CITY OF GARDEN CITY

File Number: DSRFY2021 - 0008
Application Scope: Pre-application Conference with a Request for a Public Hearing
Location: 108 W. 33rd Street Suite 106.
Applicant: Michael Leo
Report Date: March 15, 2021

Staff Report
Prepared by Hanna Veal

SOUTHEAST ELEVATION – FRONT

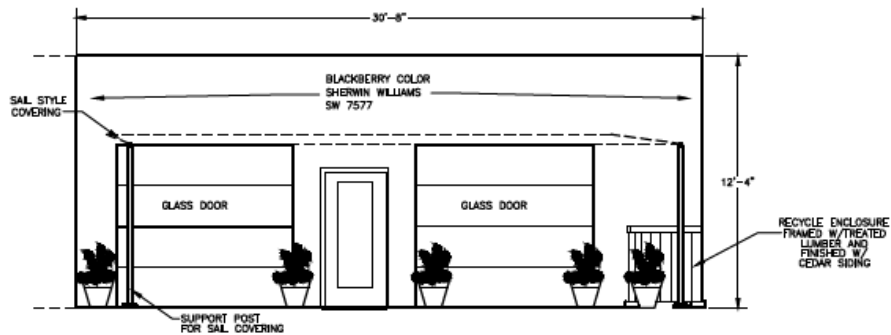
Title 8, Chapter 4: Design and Development Regulations			
8-4A-3 Fences and Walls	DC	No compliance issues noted	No fencing proposed.
8-4A-4 Outdoor Lighting	DC	Compliant as conditioned	1 proposed exterior light. 75 watts with a photometric value of 12. Design of light fixture not disclosed.
8-4A-5 Outdoor Service and Equipment Areas	DC	May not be complaint – compliant as conditioned	<p>Trash enclosure proposed along the Stockton property line, this is an encroachment that which will need to be remedied.</p> <p>Materials are made of lumber and finished cedar siding. Height of the enclosure was not provided. Need more information to review.</p>
8-4A-7 Stormwater Systems	DC	Compliant as generally conditioned	Need more information to review.
8-4A-8 Utilities	DC	Compliant as generally conditioned	Need more information to review.
8-4C Design Provisions for Nonresidential Structures	DC	No compliance issues noted	<p>Not applicable per code: The storefront renovations do not account for 25% or more of the unit, nor the entire building.</p> <p><i>Objective 1: The design of all structures shall have a scale, massing and urban form that has a relationship to the street, the pedestrian, and adjacent properties.</i></p> <ul style="list-style-type: none"> As a note, there is a blank wall facing Stockton Street and there appears to be a proposal to install a painted

<p>sign for Khaos Coffee along the upper left portion of this blank wall. Code requires that no blank walls should front a public street and that blank wall shall be treaded either by installing vertical trellis for climbing vegetation, providing a landscape bed to obscure or screen the wall's surface, or provide artwork (mosaic, mural, sculpture, etc.) over at least 50% of the blank wall.</p> <p><i>Objective 2: The design layout of all sites shall maximize opportunities for safe and comfortable pedestrian accessibility and minimize the obtrusive effects of parking and vehicular circulation.</i></p> <ul style="list-style-type: none"> Note: Pedestrian pathways should be designed to provide a direct connection between the main building entrance and the public sidewalk. There is currently no proposed connection to the proposed painted pathway along 33rd street. However, the applicant is proposing a crosswalk from the painted pathway to the proposed location of the shared parking agreement parking lot. <p><i>Objective 3: Buildings shall be designed and constructed of quality materials.</i></p> <p><i>Objective 4: The site design shall respect existing notable site features including existing buildings, landscaping, trees and water.</i></p> <p><i>Objective 5: The design of all buildings shall provide visual interest, support the vision for the area as articulated in the comprehensive plan and positively contribute to the overall urban fabric of the community.</i></p> <p><i>Objective 6: The site development should support and be consistent with the adopted streetscape.</i></p>
